ADDENDUM NO. 1

**RE: Item #3, October 16, 2024 Letting - BRO-B 8052(77), PCN 08N3, Pennington County -
Structure (80' Prestressed Girder Bridge) & Approach Grading**

PLANS: Please destroy sheet 40 and replace with the enclosed sheets, dated 9/25/24.

SHEET
40

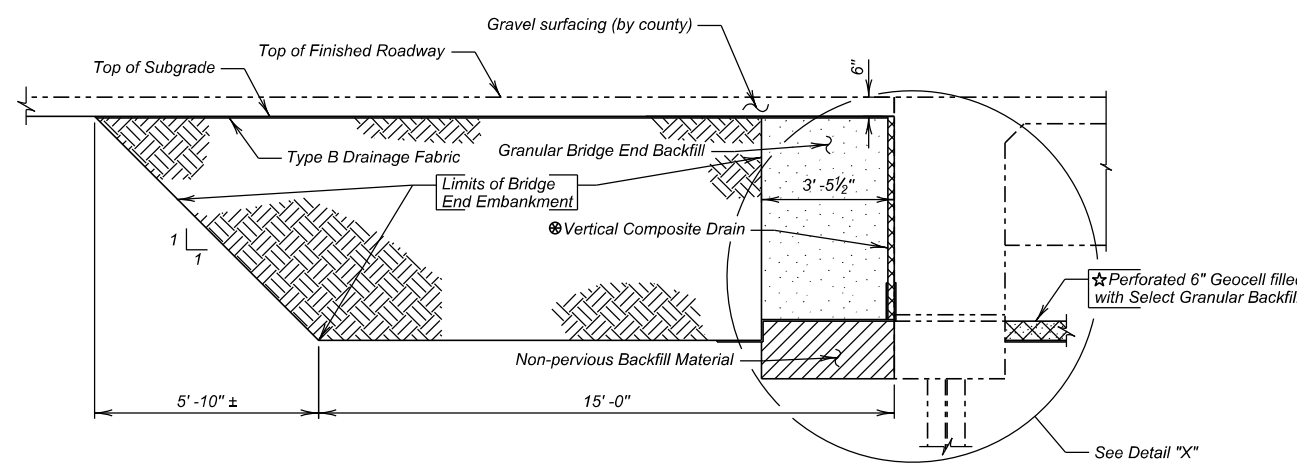
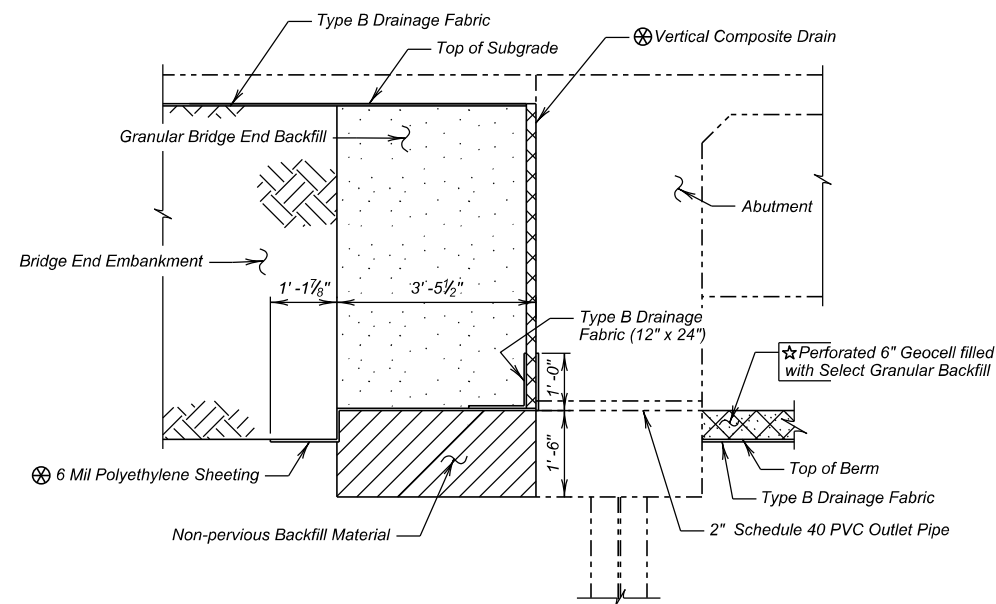
Sheet 40: Informational Item 4 was revised. Type B Drainage Fabric changed from 64 to 187 SqYd. Type B Drainage Fabric note was added to SEC. A-A and DETAIL "X".

- 336 sq. ft. 6 mil polyethylene Sheeting, not including laps
- 187 sq. yd. Type B Drainage Fabric.
